City of Ramsey
Agenda
Park and Recreation Commission
Thursday, May 11, 2017

**CITY OF RAMSEY LAND USE APPLICATION
TECHNICAL REVIEW FILE**

DATE	3/31/17	PROJECT ADDRESS	14800 BLOCK PUMA ST NW
PROJECT. TITLE	RIVERSTONE ADDITION (SKETCH PLAN)		
PROJECT #	17-106		
DEPARTMENT:	Community Development – Planning Division		
TECHNICAL REVIEWER:	Name: Tim Gladhill, Community Development Director Phone: 763-433-9826 Email: tgladhill@cityoframsey.com

The Engineering Department offers the following comments regarding the Sketch Plan Exhibits for Riverstone. The submittal consists of 16 sheets prepared by Carlson McCain dated March 8, 2017. The submittal included a document with the stormwater summary and geotechnical report. This review also covers the draft EAW submitted for this project.

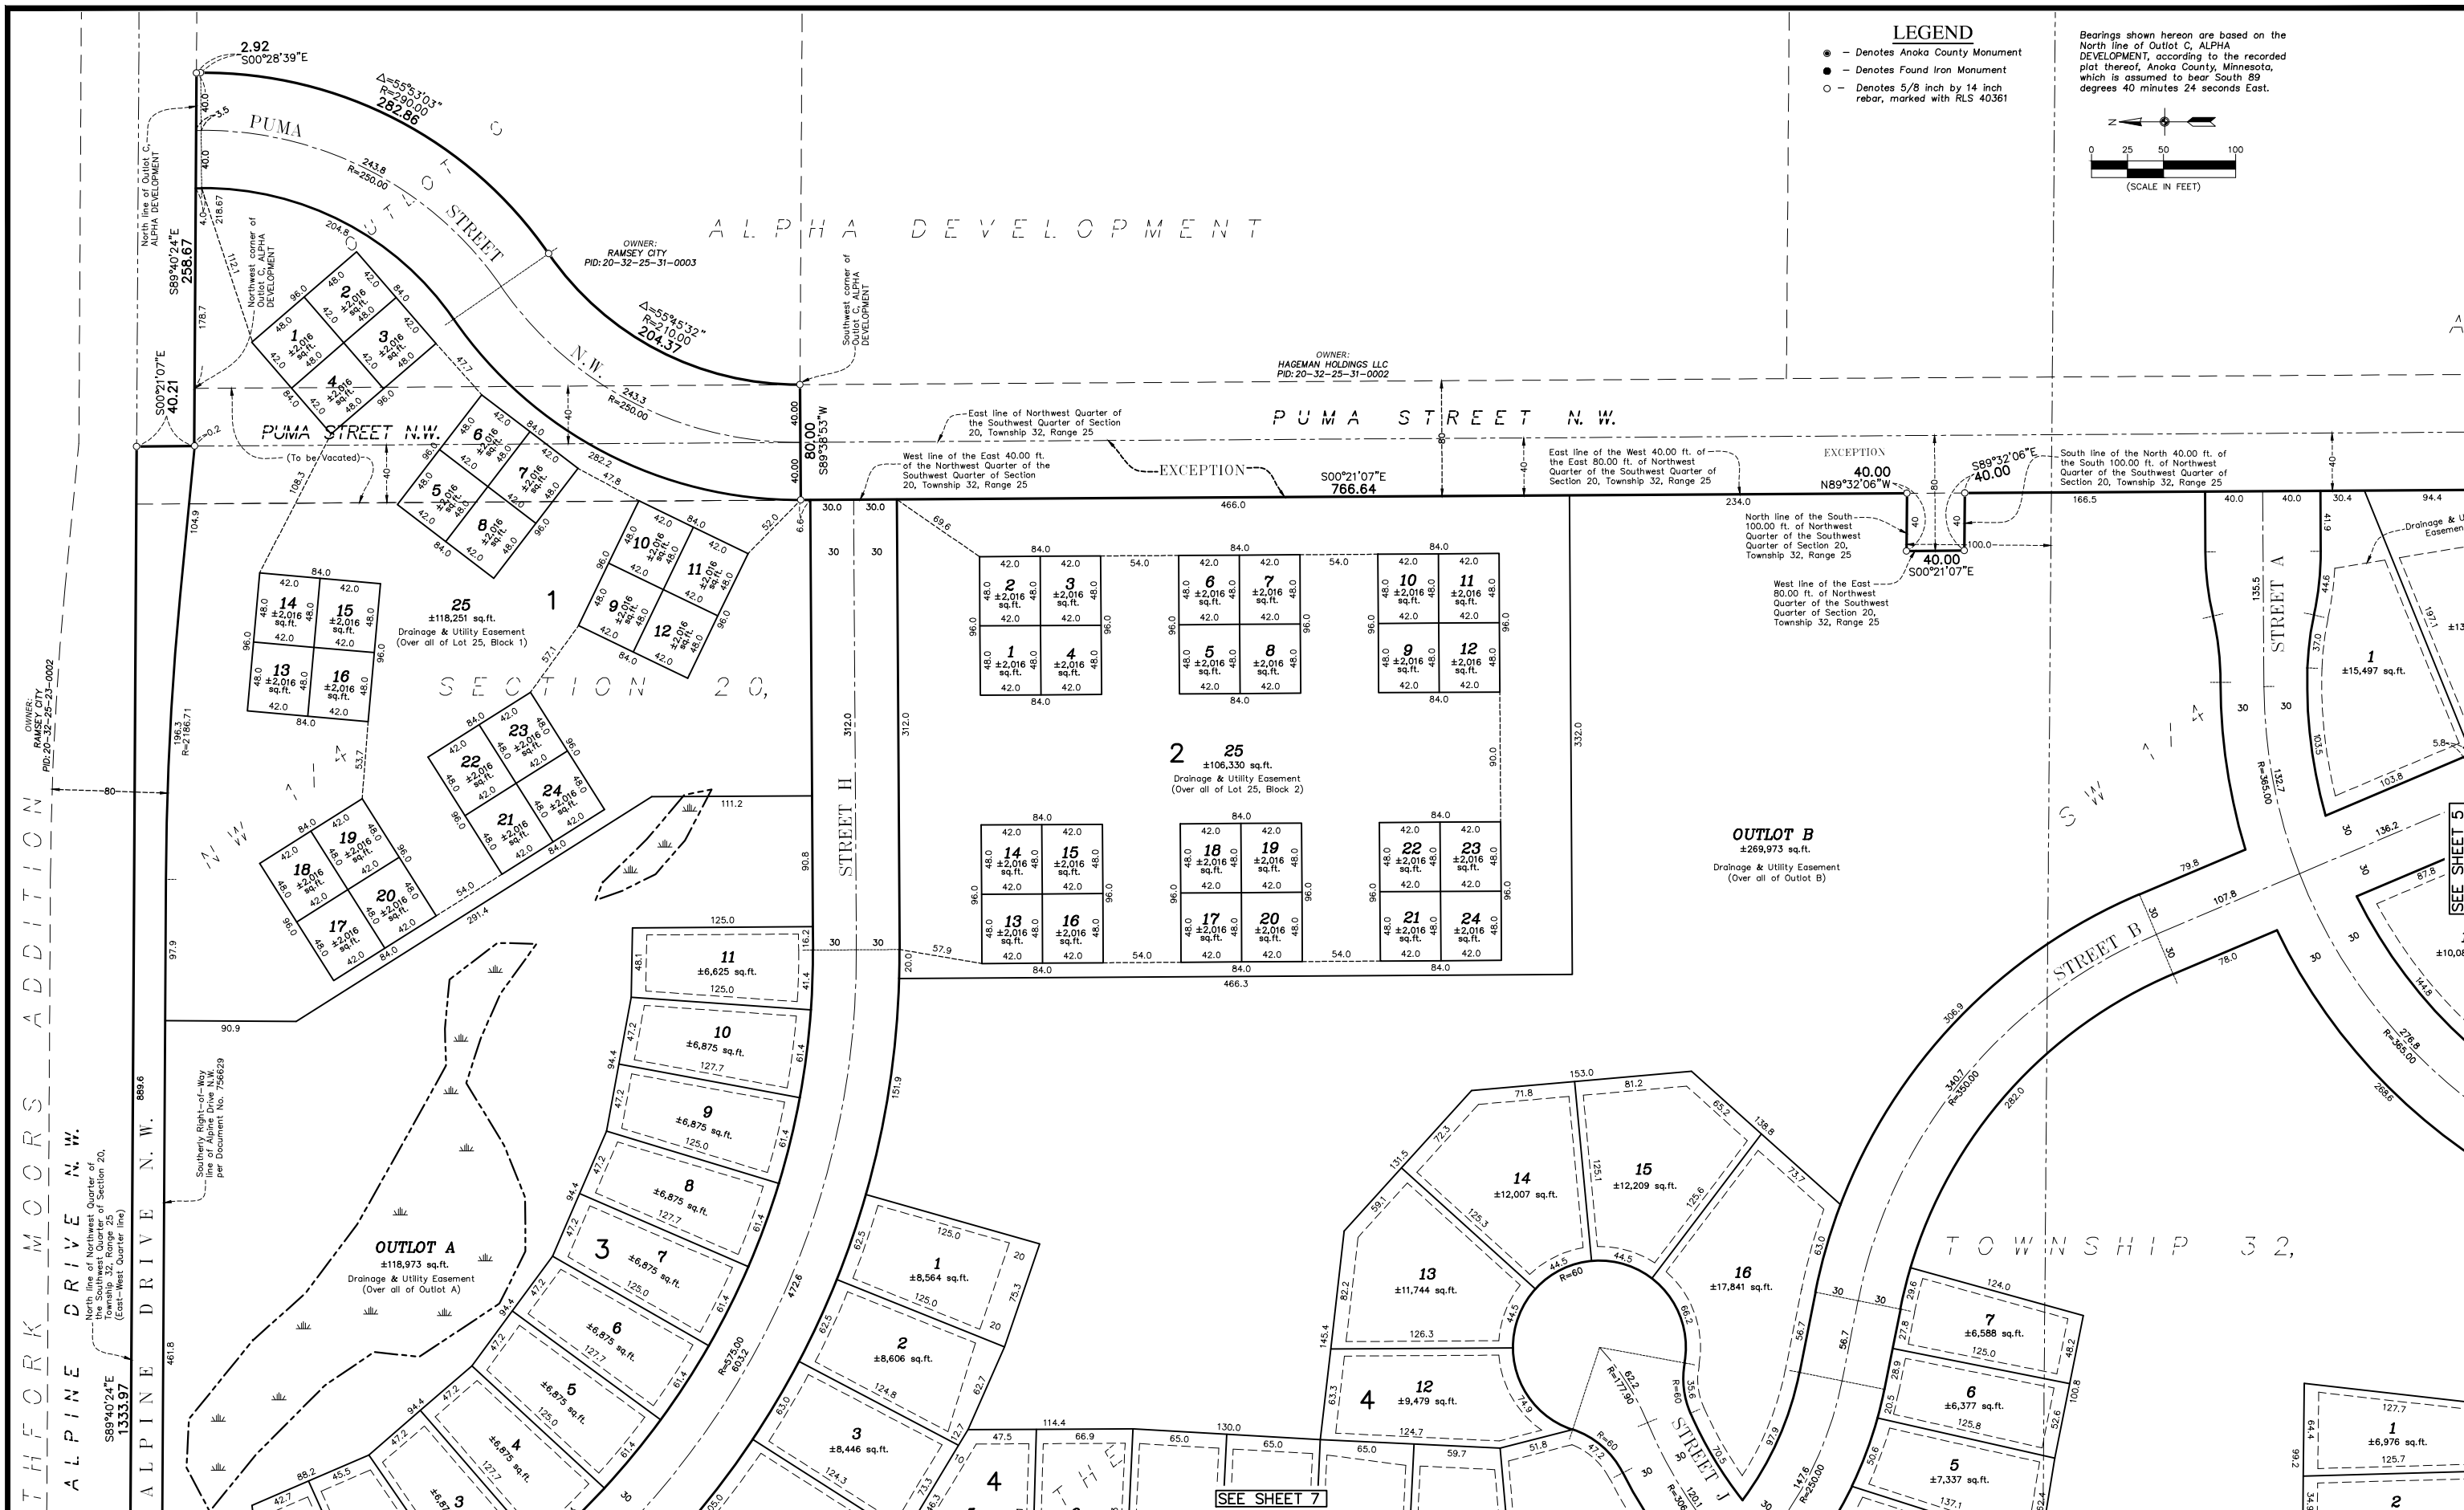
Sheet 4:

1. A drainage and utility easement must be dedicated along Puma Street for the future Lift Station. See additional comments on utility plan.

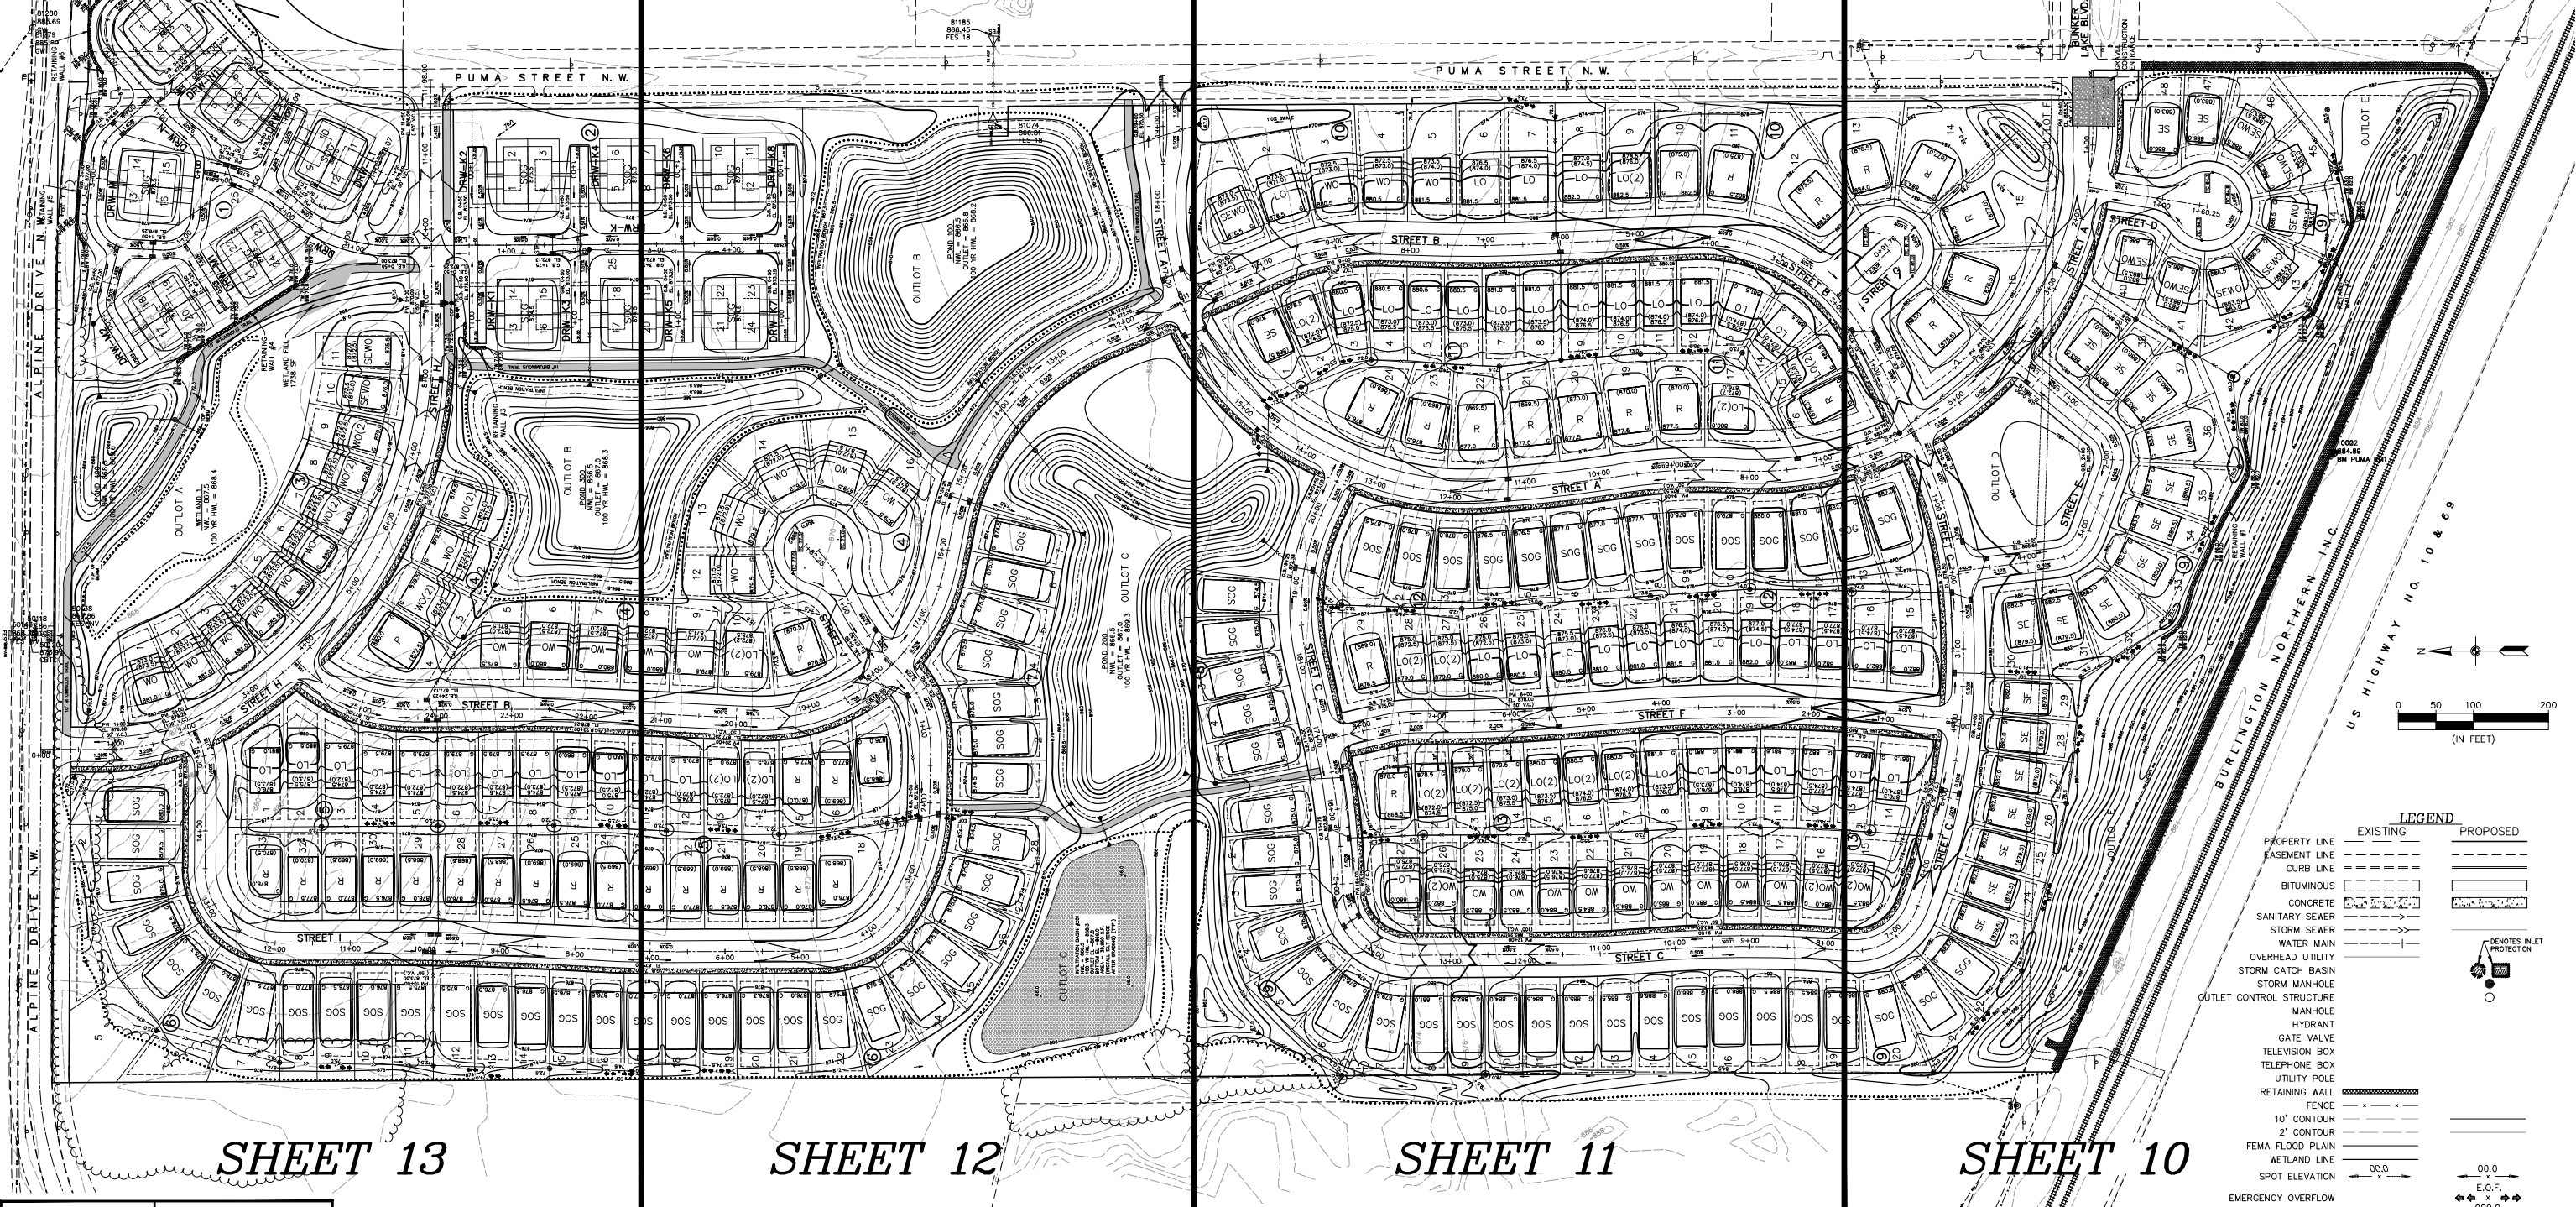
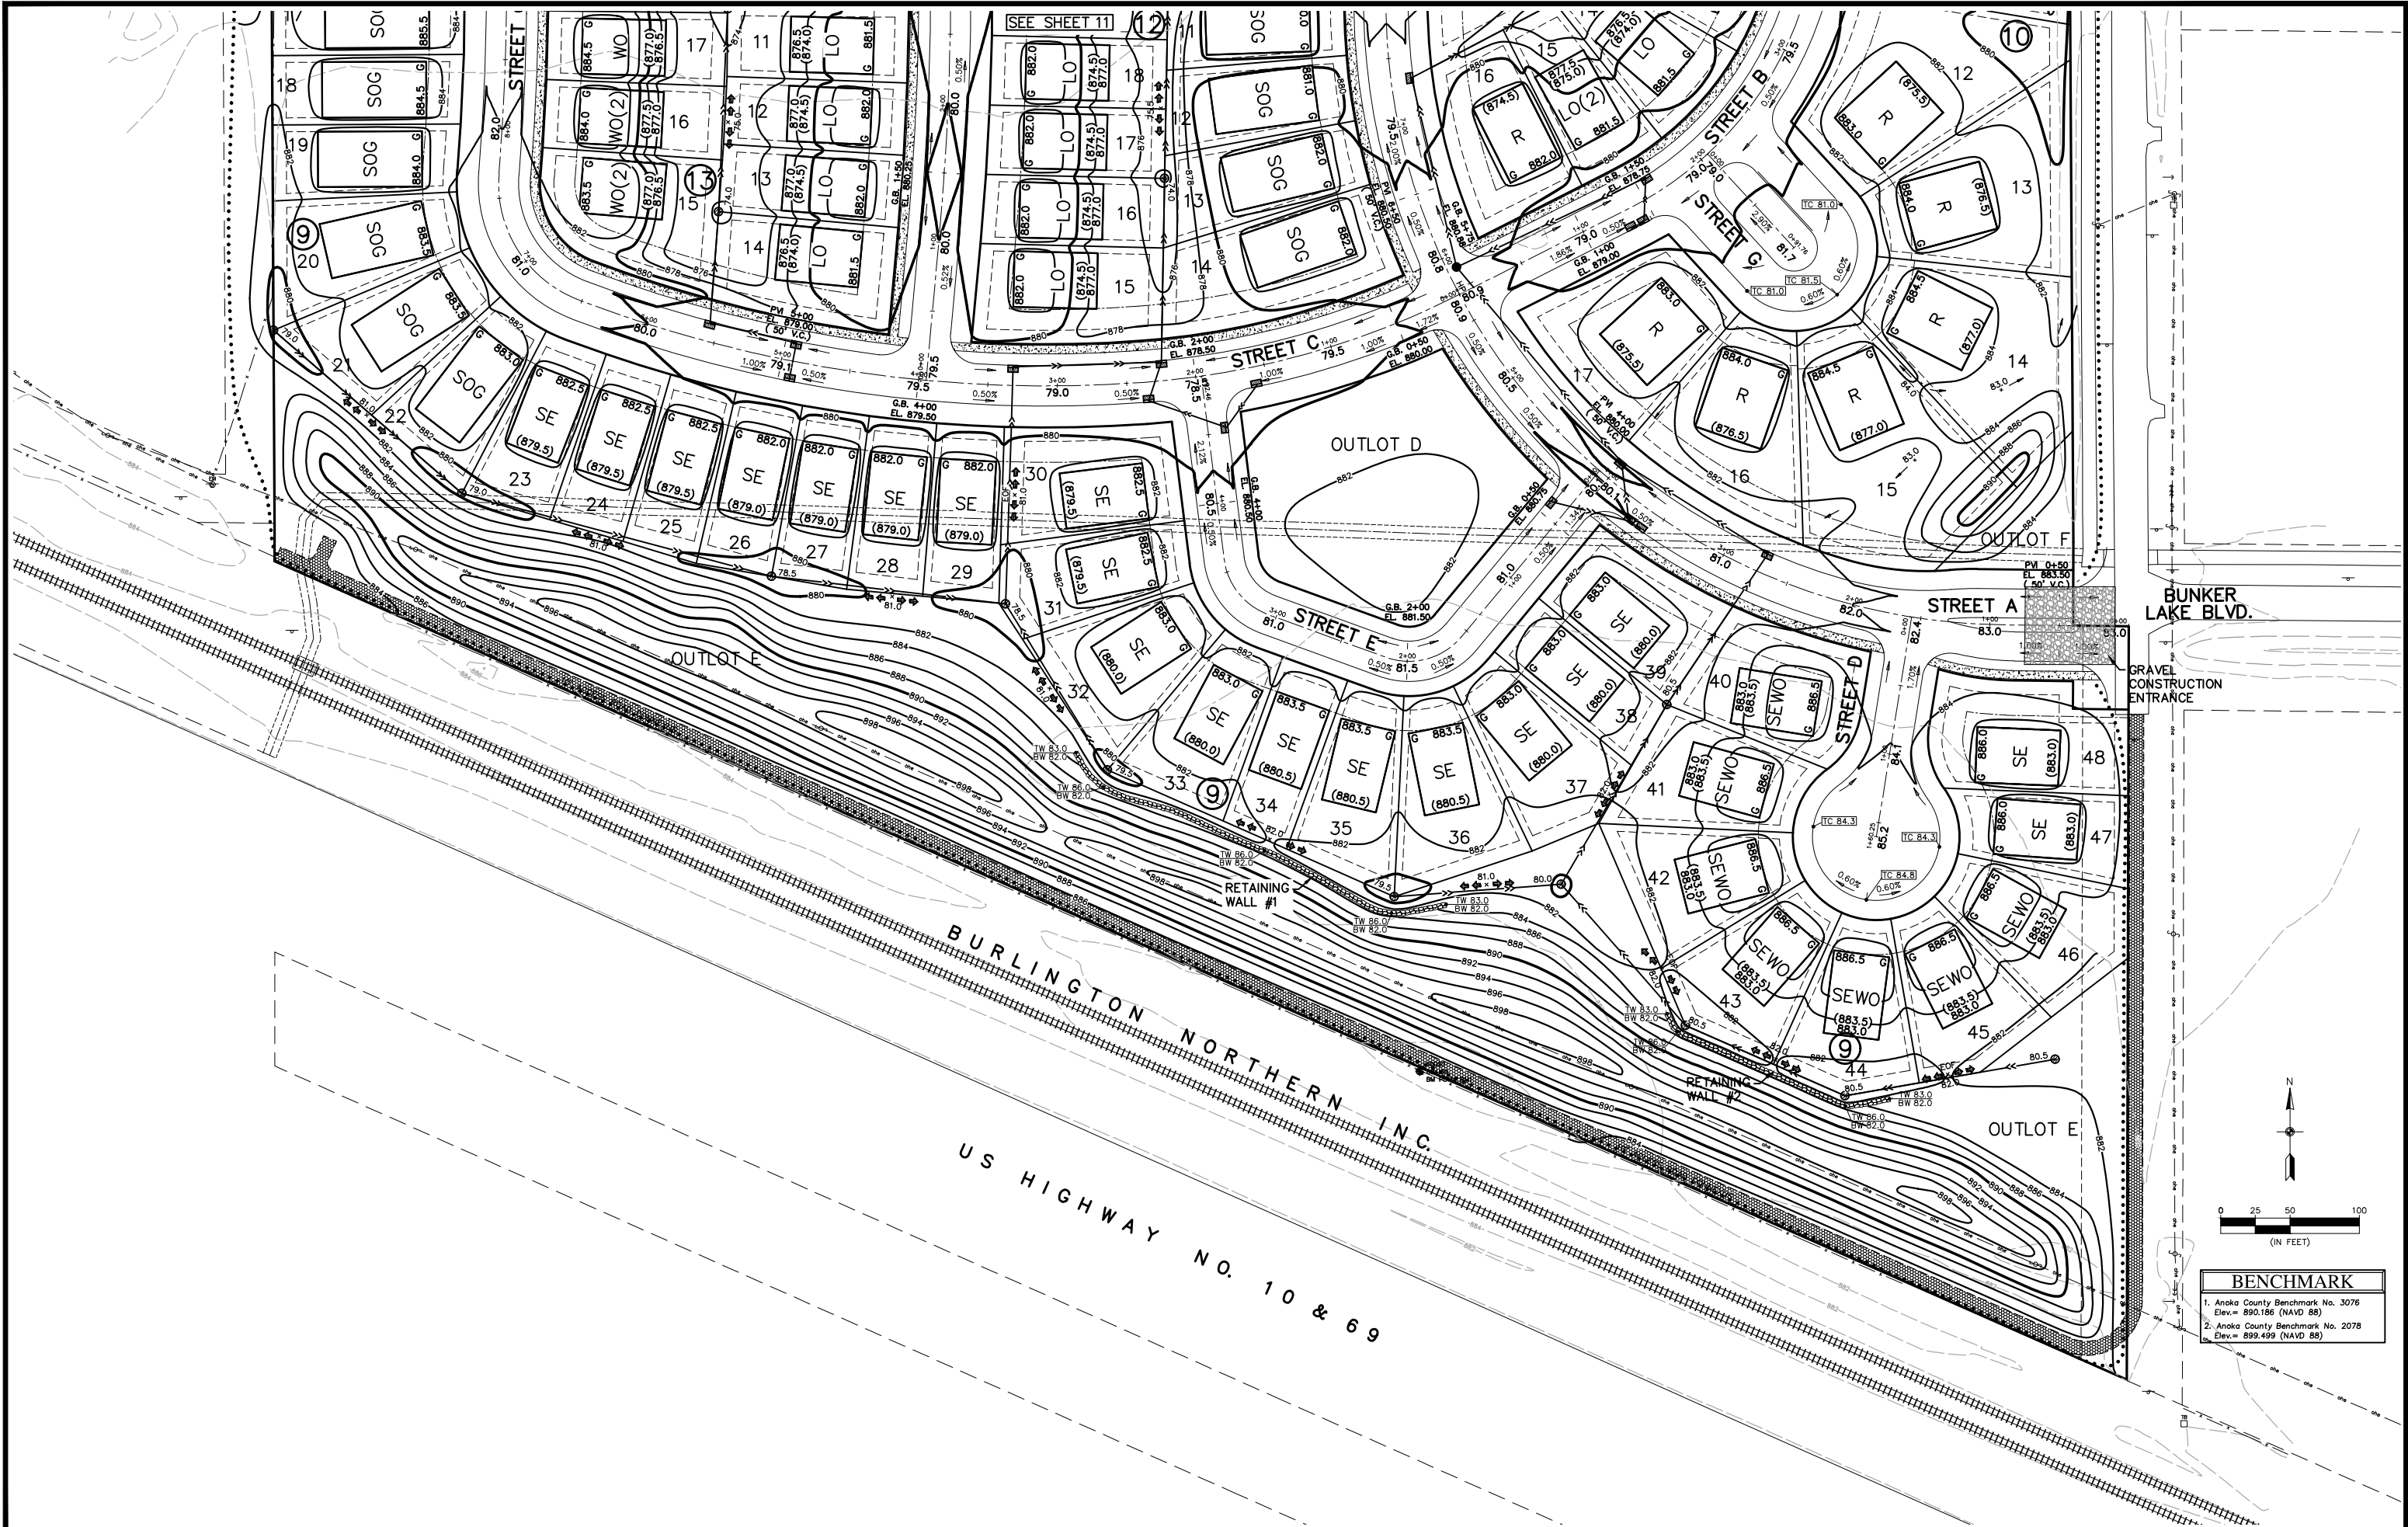
Sheet 8:

2. Water valves must be added mid-block near Lot 14, Block 9, Lot 8, Block 13, Lot 7, Block 12, Lot 14, Block 6, Lot 10, Block 5 and Lot 8, Block 11.
3. The manhole information for the structure near Lot 43, Block 9 is not correct. The rim and invert elevations are reversed. The invert elevation is lower than the downstream invert.

4. Rim and invert elevations are required on the proposed sanitary sewer in Puma Street. The responsibility for construction of this line and the lift station has not been determined; however, design information must be shown on this plan to ensure that the proposed line will function properly.
